## Products Improvement/Change Notice

<b>Change Subject:</b>	Tyre changer	<b>Issue No.</b>	PCT23003	<b>Created on/by:</b>	27.11.2023	Klaus Wu.
<b>Change reason:</b>	Continuous improvement	<b>Implementation date :</b>	20.11.2023	<b>Issued on/by:</b>	27.11.2023	Product service Dp.
<b>Changed Item:</b>	D186 Bead breaker cylinder	<b>Class:</b>	<b>Important</b>		<b>Reply Deadline:</b>	/
<b>Universality for old &amp; new</b>	<input checked="" type="checkbox"/> Fully Universal <input type="checkbox"/> Partially Universal <input type="checkbox"/> Non-Universal	<b>Issued to:</b>	Stable purchase of customers configured with D186 large cylinder tyre changer <b>Note: This change applies to the models listed below, corresponding to the models with suffixes.</b>		<b>Policy and Solution:</b>	
<b>Change Content:</b>	Cancel the connector, install the exhaust valve directly on the cylinder					
<b>Photos/Details:</b>		<b>Changed Machine Models:</b>	<p><b>U serie</b> U-200U, U-2011, U-2019, U-2022, U-2022M, U-206, U-221, U-226, U-227, U-6603, U-6691, U-6692, U-6697, U-6698, U-6631, U-6656, U-6657</p> <p><b>PL serie</b> PL-1206, PL-1211, PL-1219, PL-1221, PL-1226, PL-1227, PL-1261, PL-6003, PL-6091,

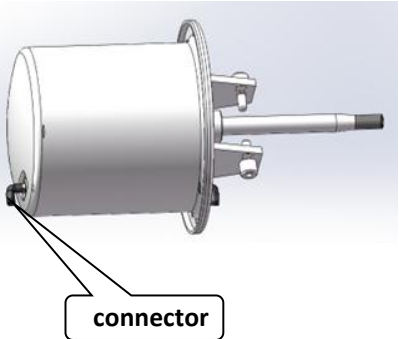
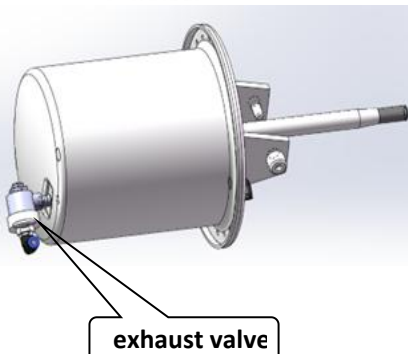
<div> <p><b>Old</b>      JZ06001060664</p>  <p>Exhaust valve is connected with the cylinder connector</p> </div> <div> <p><b>NEW</b>      JZ06001020265</p>  <p>Exhaust valve is directly installed on the cylinder</p> </div>
